POWERTECH (USA) INC.

RE: Revised Technical Report (TR); Powertech (USA) Inc.'s Proposed Dewey-Burdock Project; Docket No. 40-9075

CHANGE INDICES

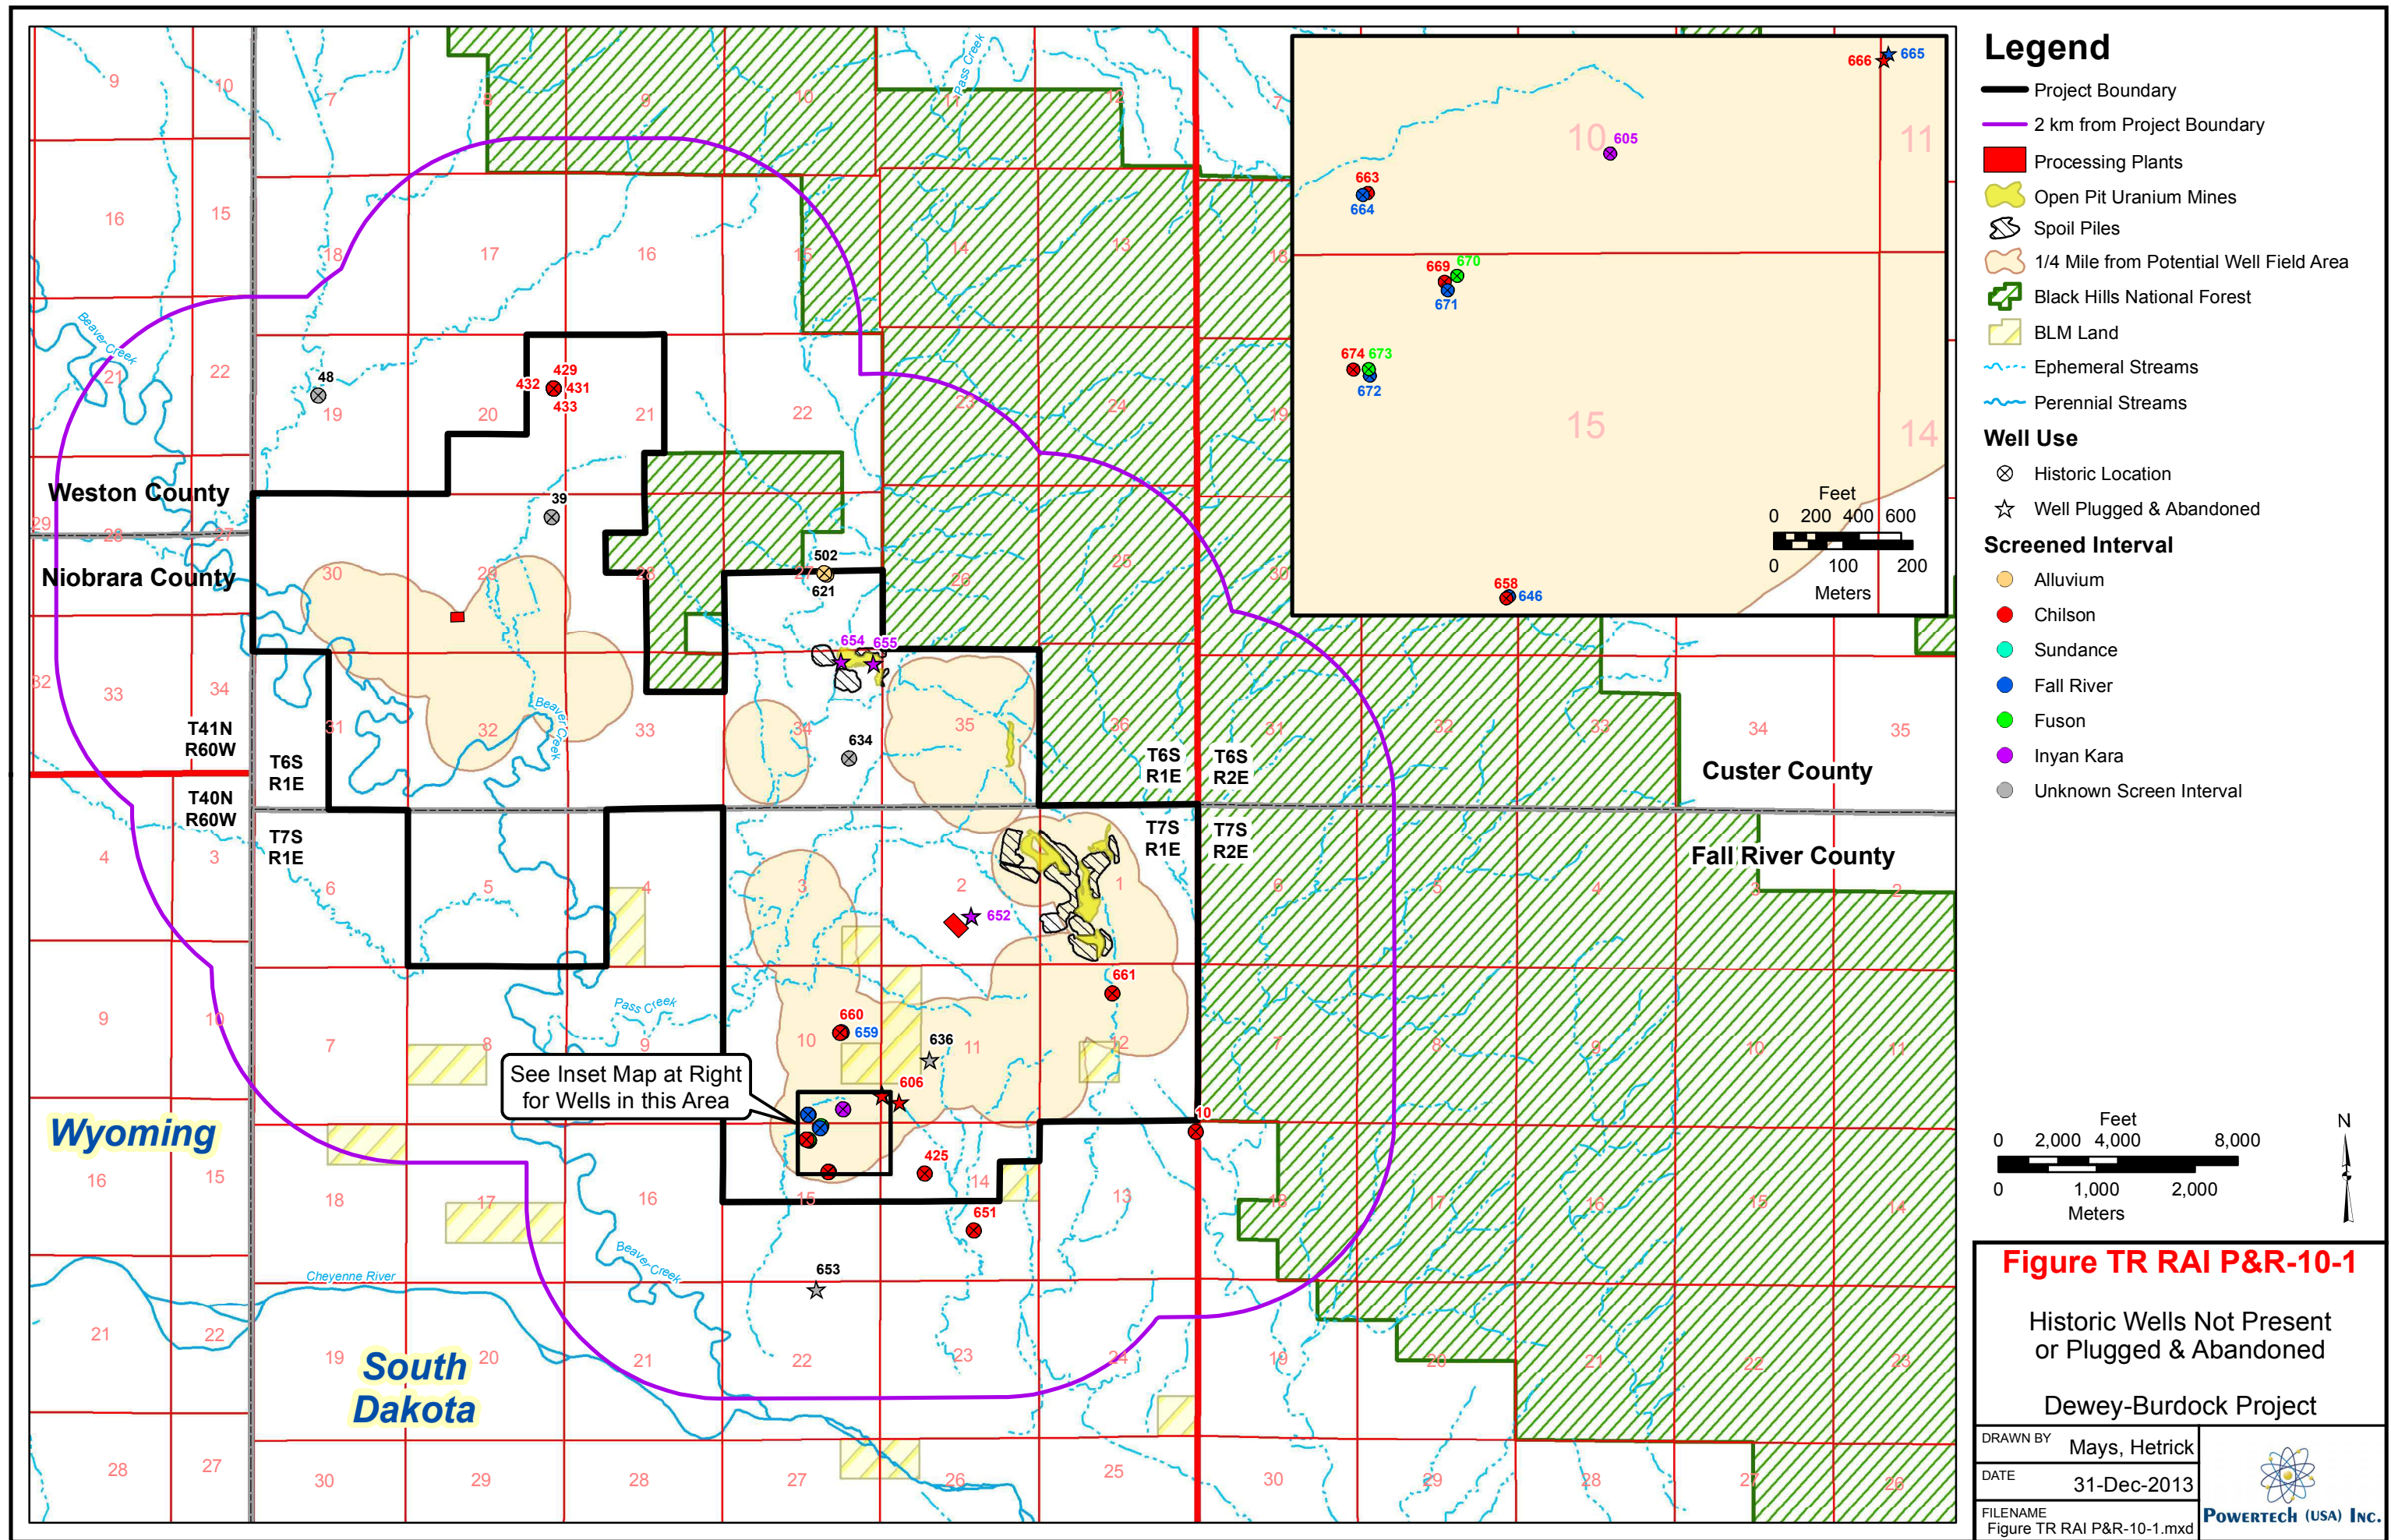
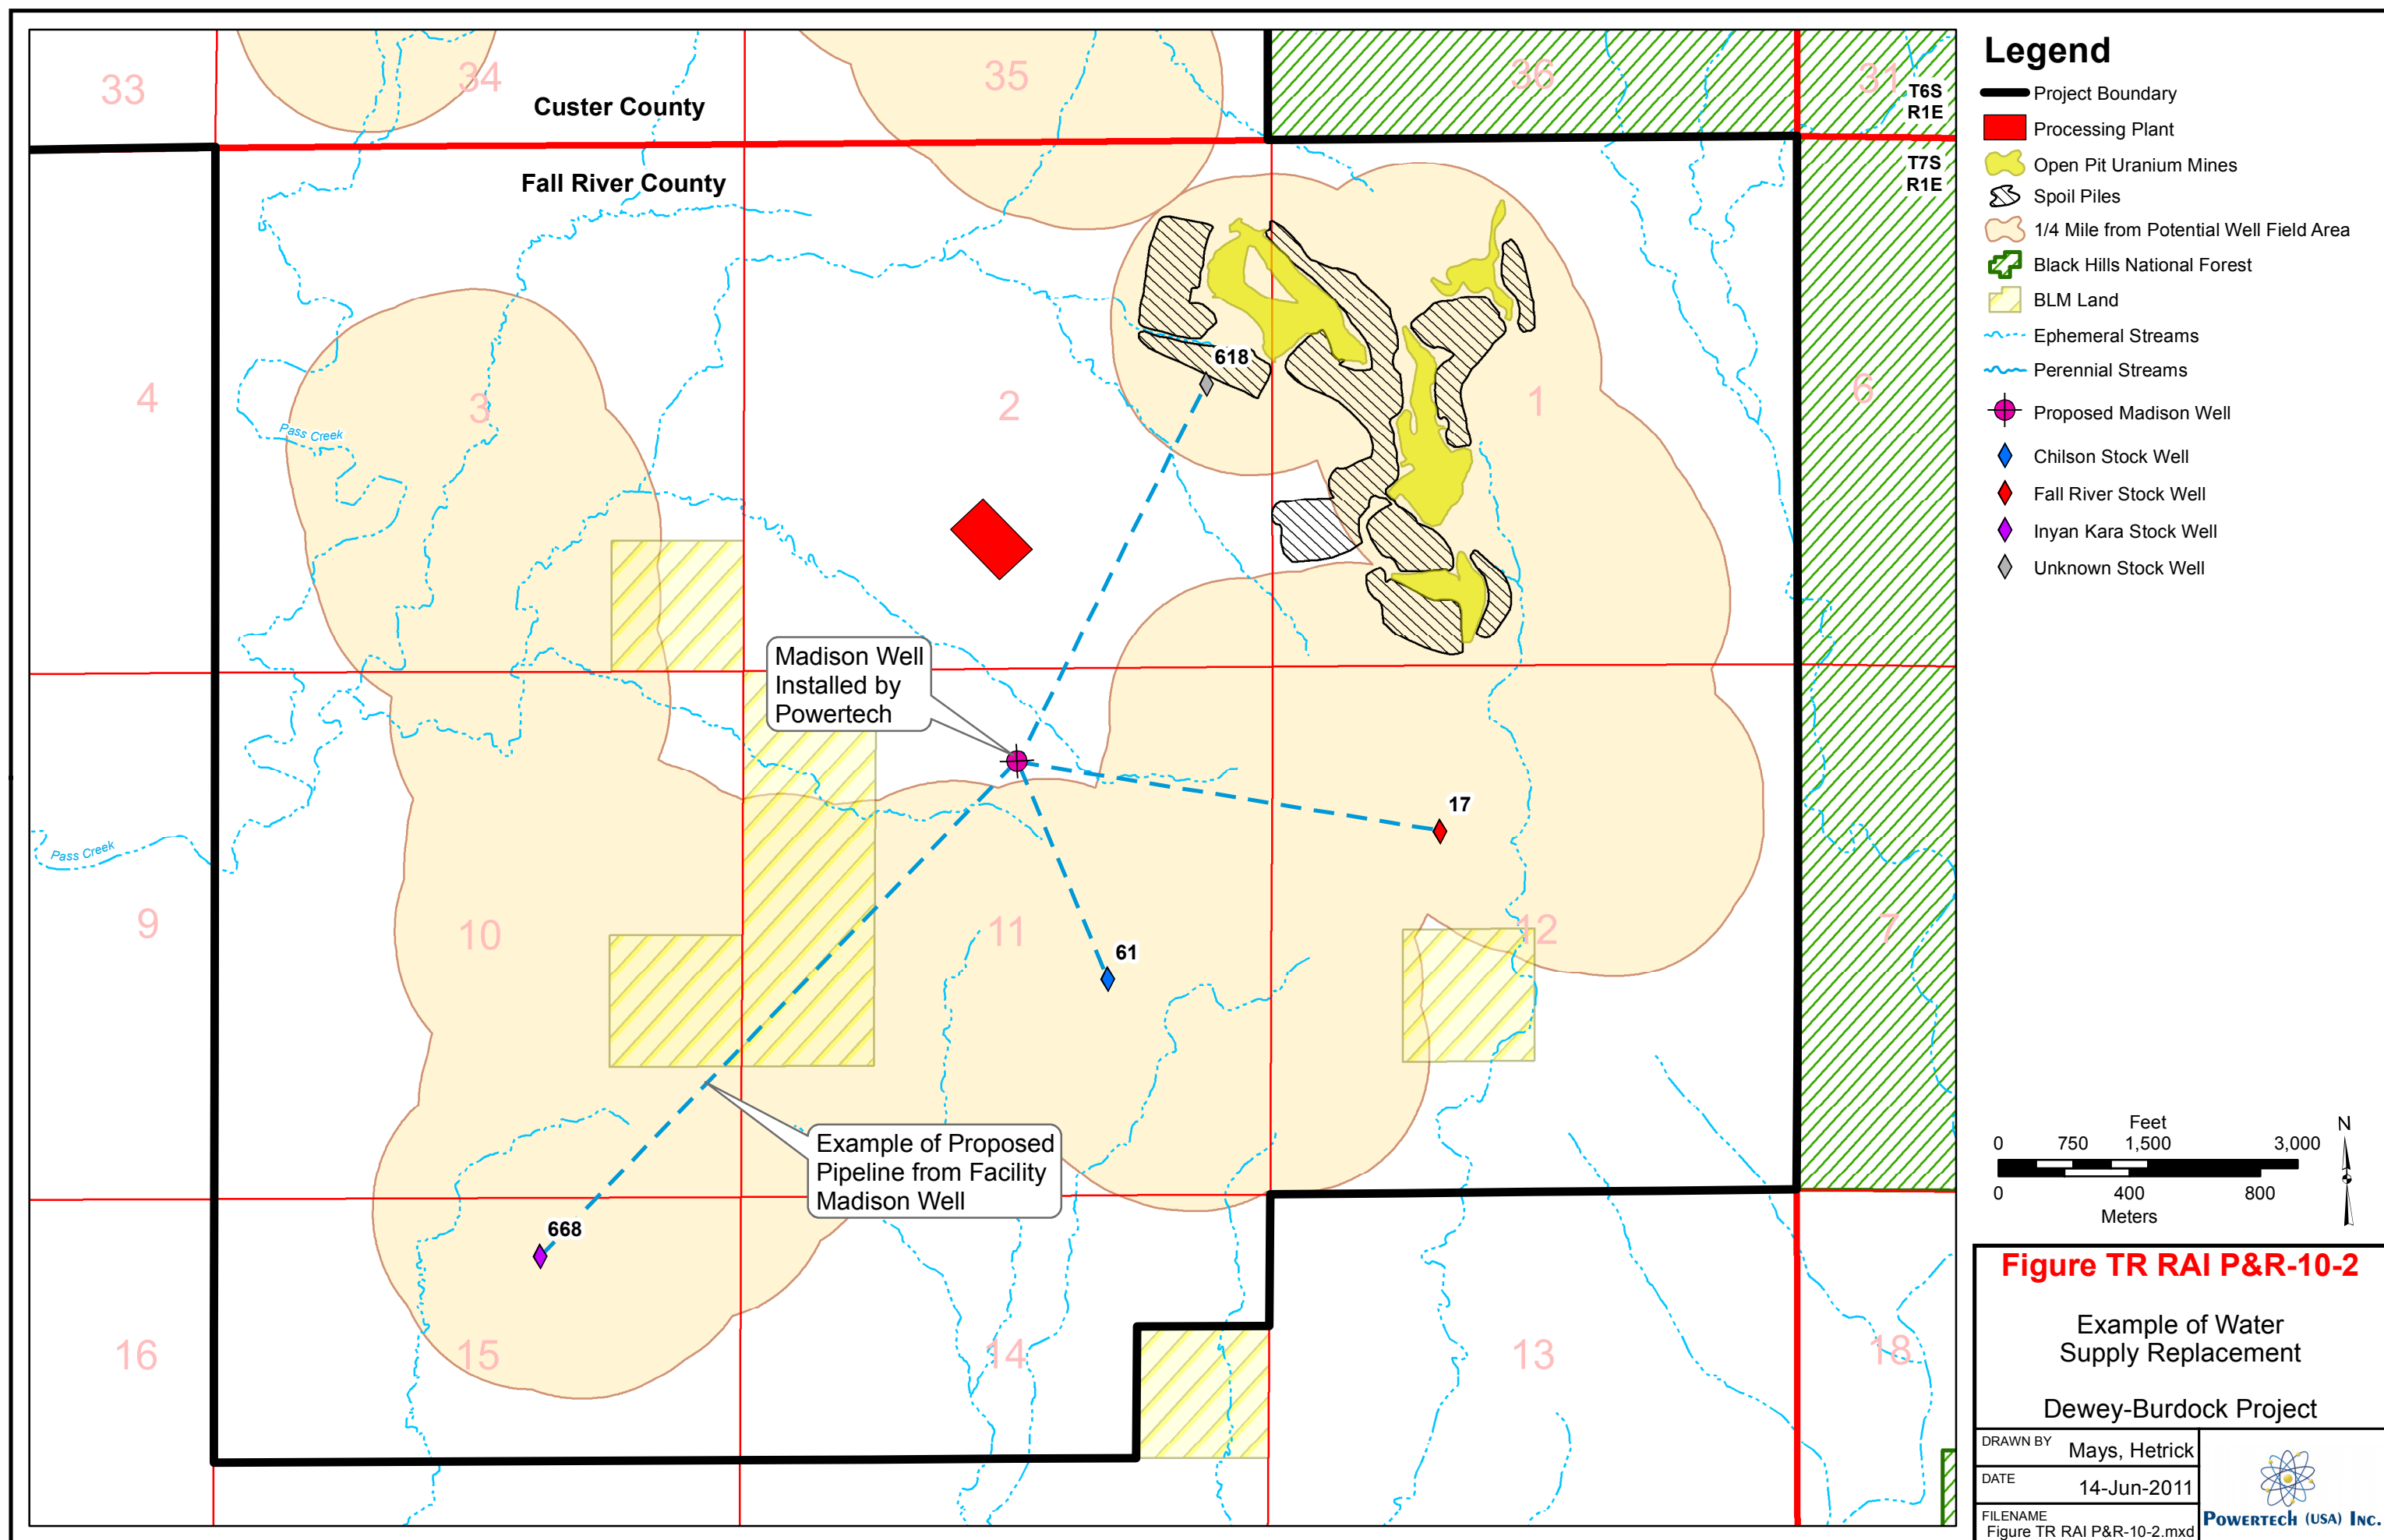
Revised tables presenting the inventory of all wells within 2 km (1.2 miles) of the project boundary are provided within this response. Well completion records and associated documentation will be provided in Appendix 2.2-B in the revised TR. Exhibit 3.1-1 of the TR has been revised to include all wells within 2 km of the project boundary and is included with this response package. The revised Exhibit 3.1-1 also will be included with the revised TR. The following information will be incorporated into the revised TR.
